**ADDENDUM 01**

Addendum #	01	Date Issued	03/21/2025
Project Name Job #	SWN 0509, Waneta Hall Renovate Restrooms	OSE #	R0325--15X
		EAPC #	20256780
Bid Date Time	April 3, 2025		3:30pm

PROJECT DESCRIPTION
SWN 0509, WANETA HALL RENOVATE RESTROOMS (OSE# R0325--15X)

DRAWING TITLE
 FIRST FLOOR PLUMBING PLANS

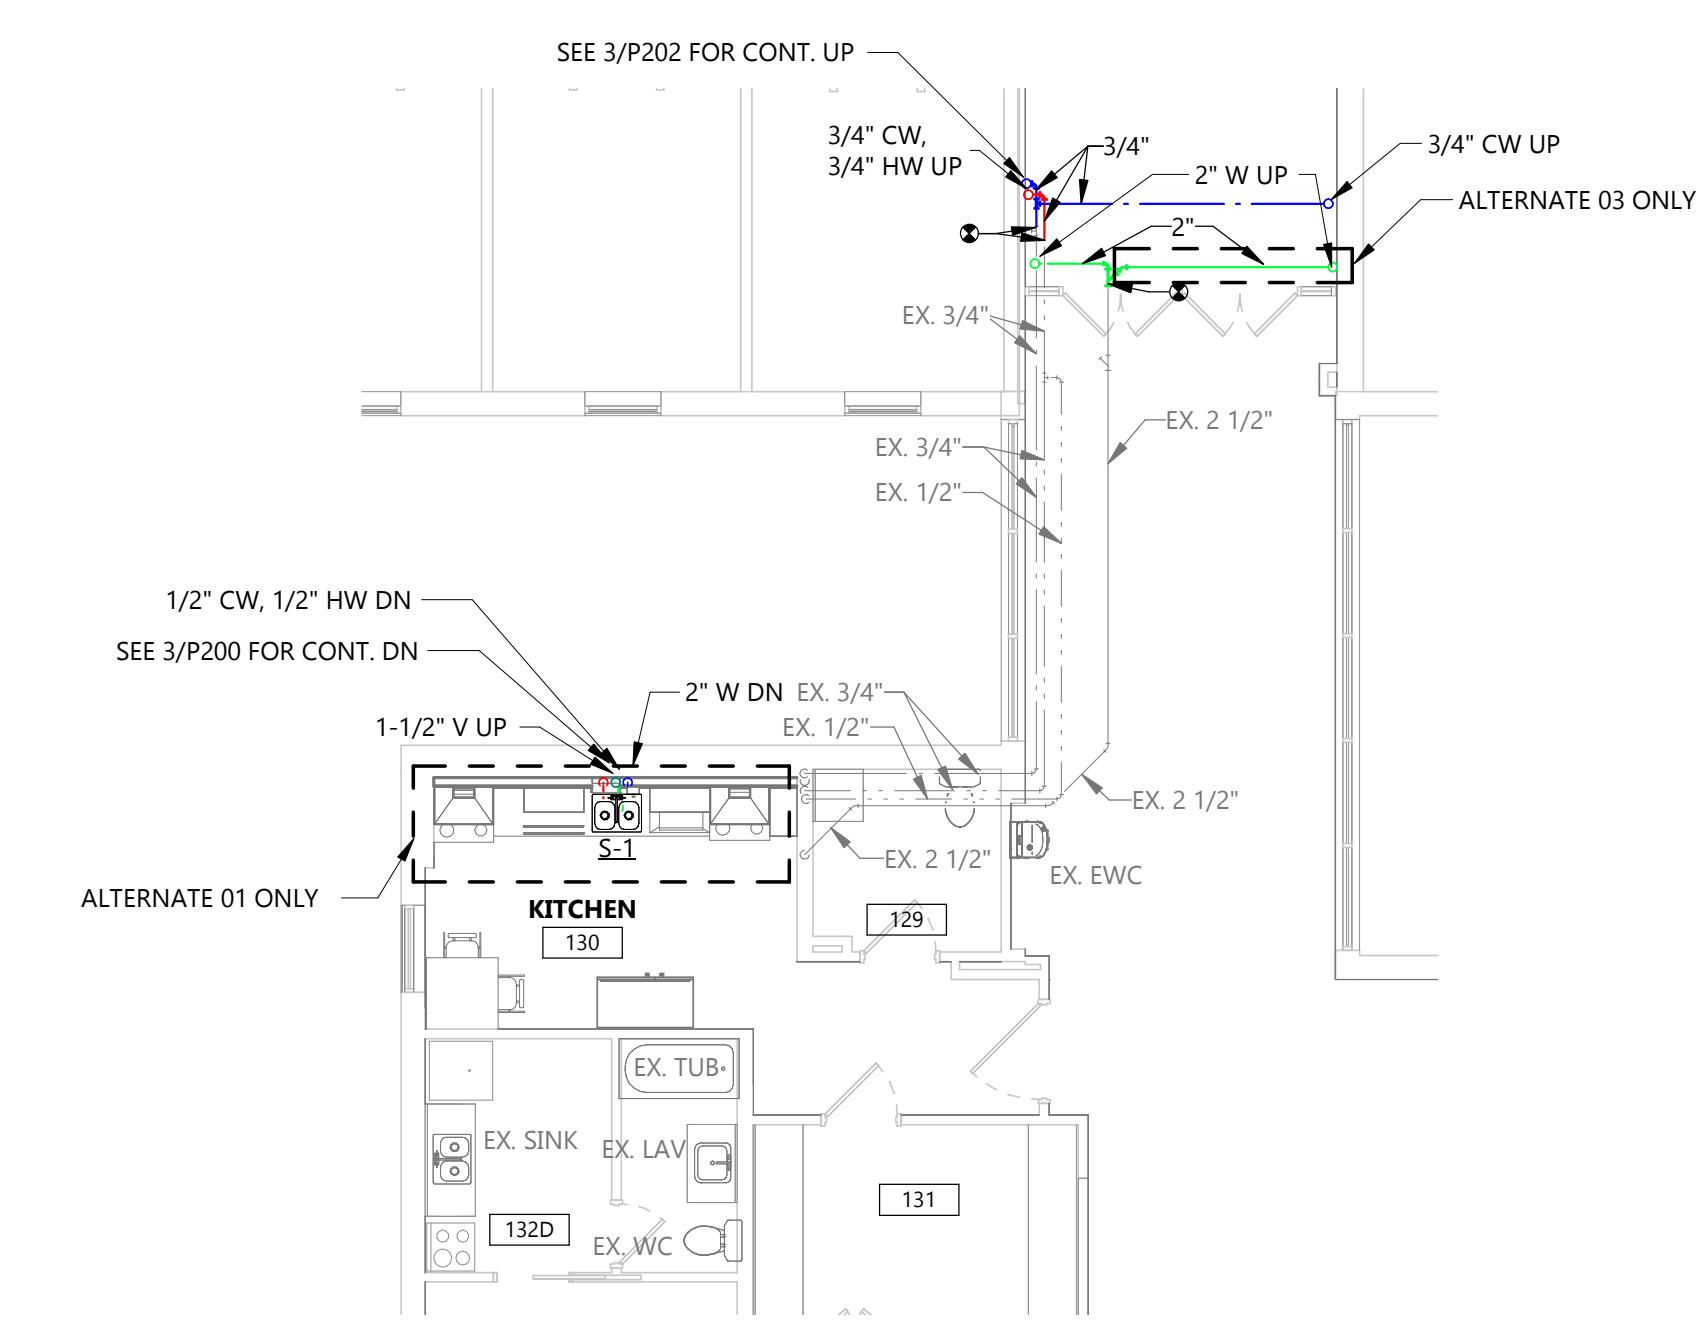
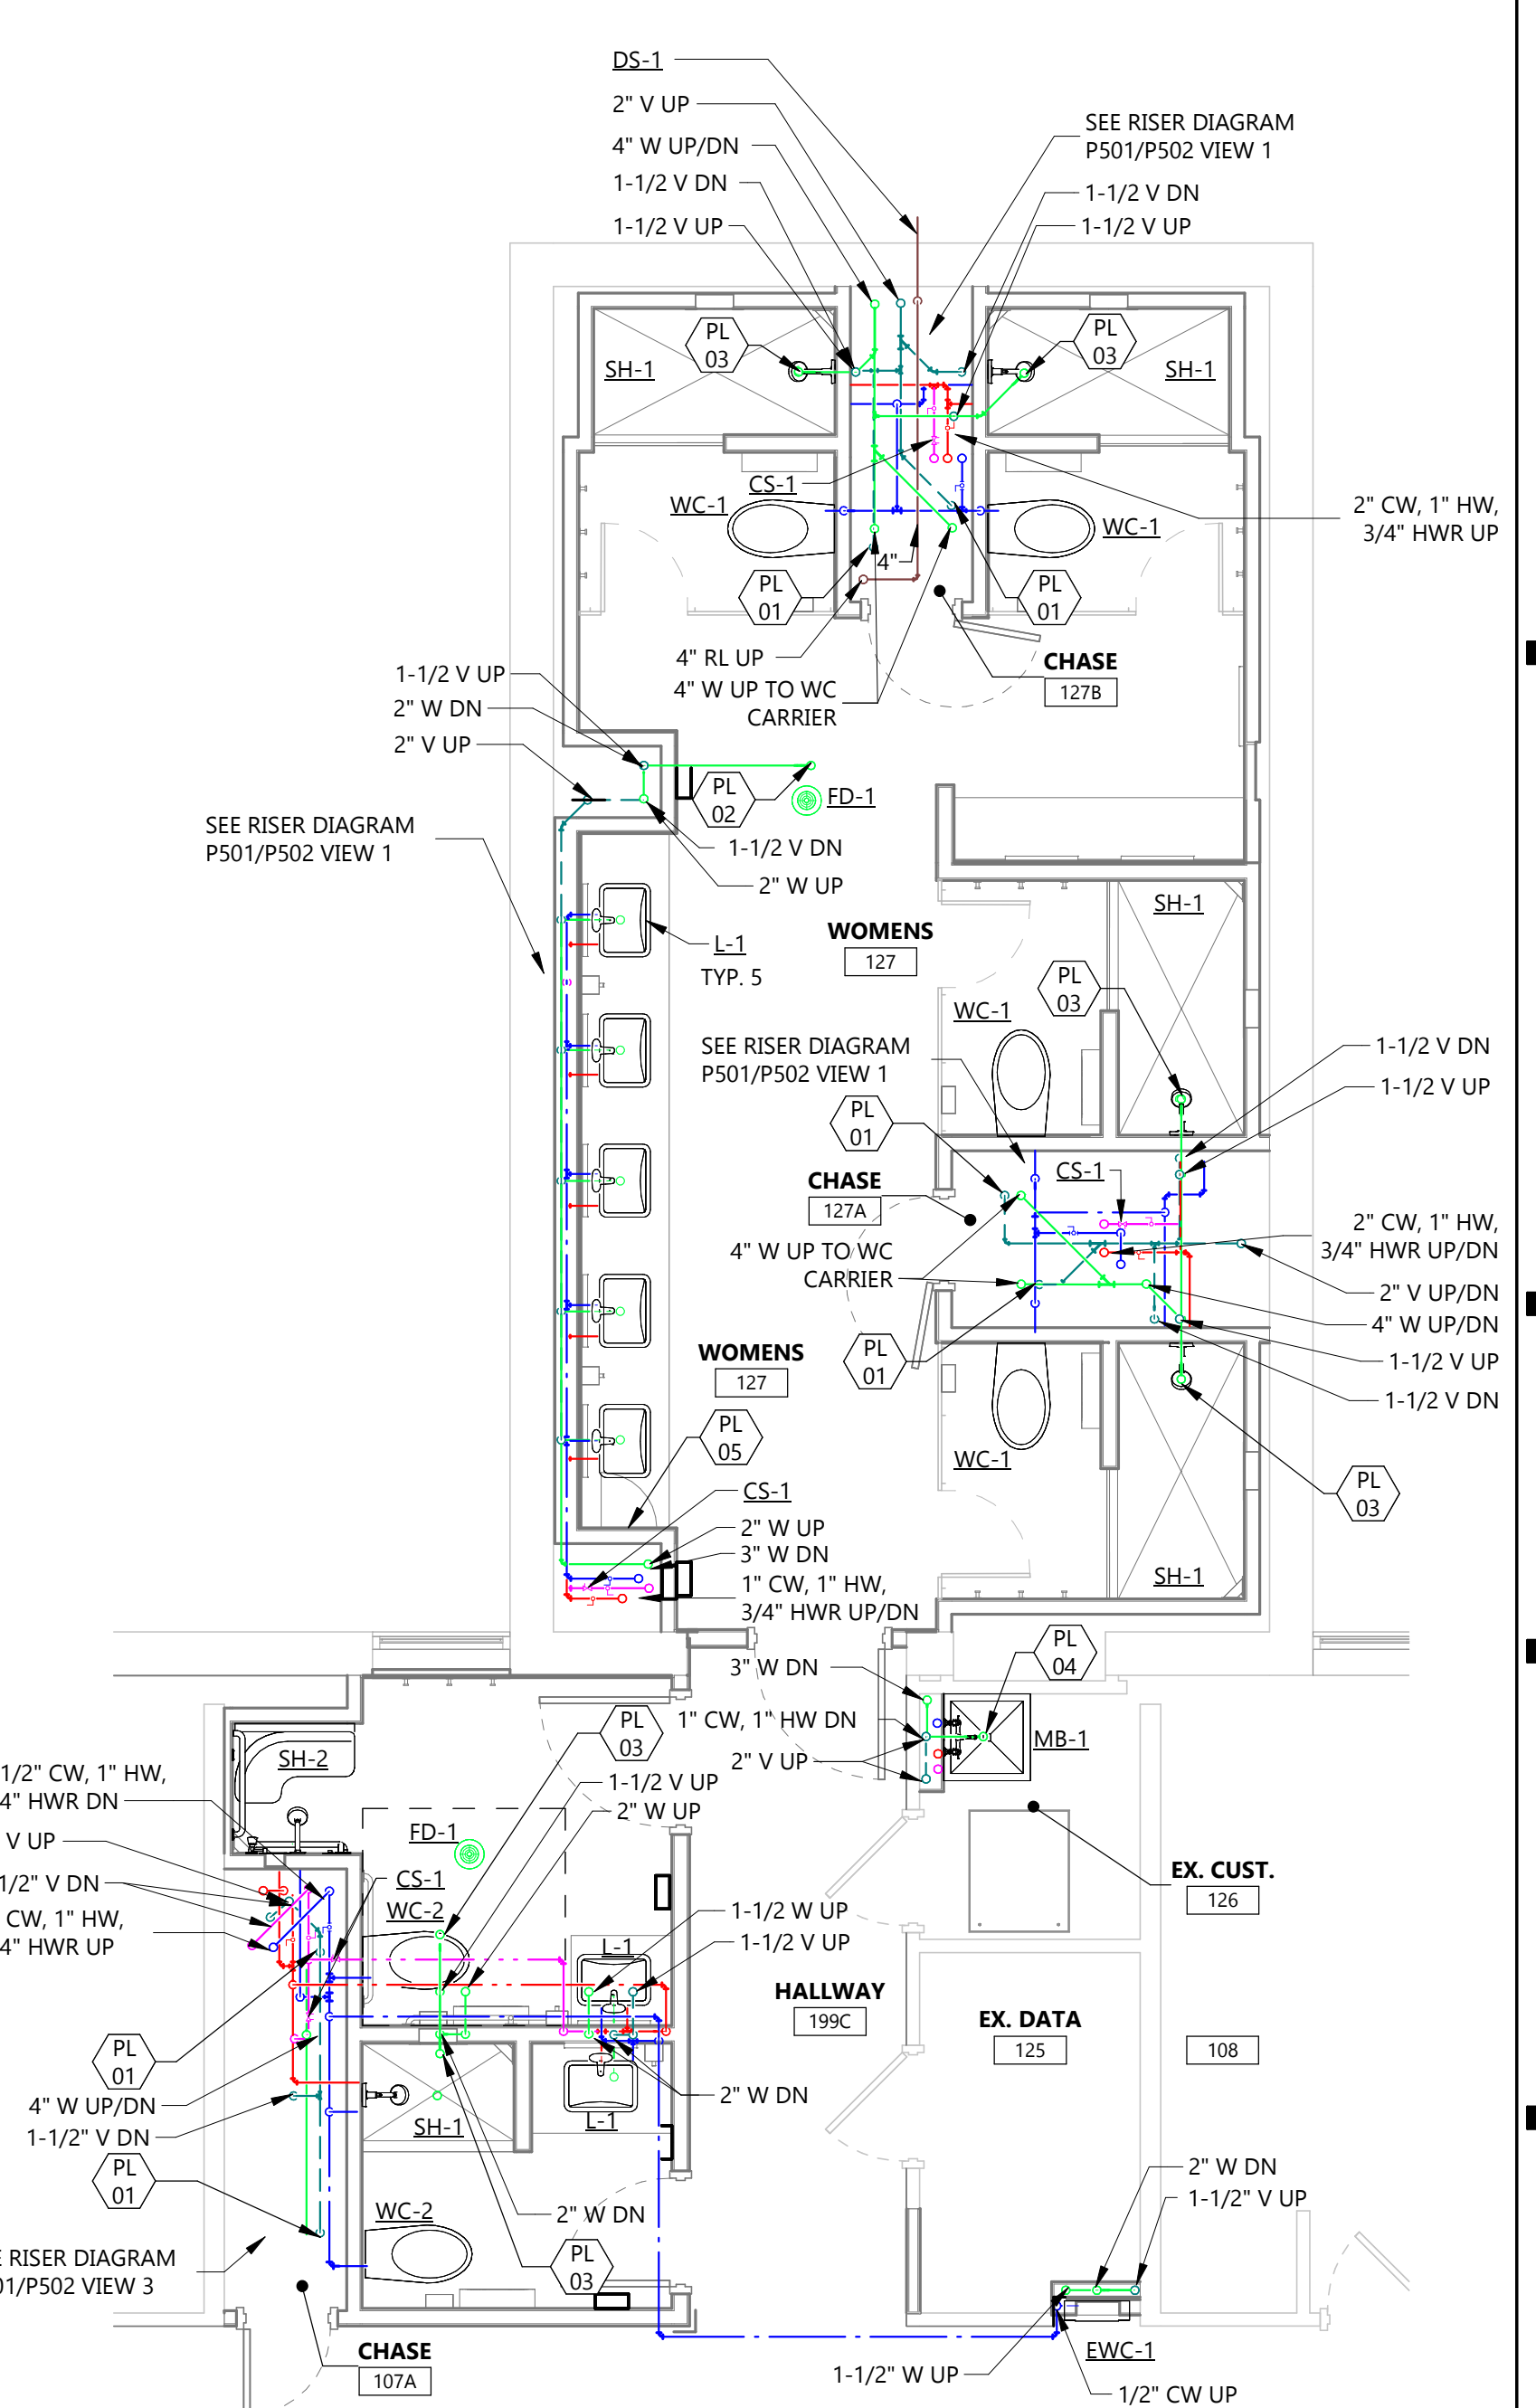
P200	REVISE plumbing pipe routing to stay within tunnel space regarding Alternate 02 work.
P201	REVISE plumbing pipe routing in wall associated with Alternate 02.
M201	REVISE ERU's and associated ACCU's locations for concrete pad and clearances.
M301	REVISE ERU and ACCU locations for concrete pad and clearances. ADD section view for ductwork installation.
E101	CLARIFIATION on existing panel names.
E102	CLARIFIATION on panel names.
E103	CLARIFIATION on panel names and demo at RM 326.
E200	ADD location for MDP.
E201	ADD location for mechanical equipment and duct smoke detectors. Add clarification on alternates. REVISE power at alternates ADD notes 5 and 6.
E202	ADD clarification on alternates. Add notes 3 and 4. REVISE power at Study rooms
E203	ADD note 4 for data rough in. Update power at Study rooms
E301	ADD clarification on lighting types and occupancy sensors.
E302	ADD clarification on lighting types and occupancy sensors.
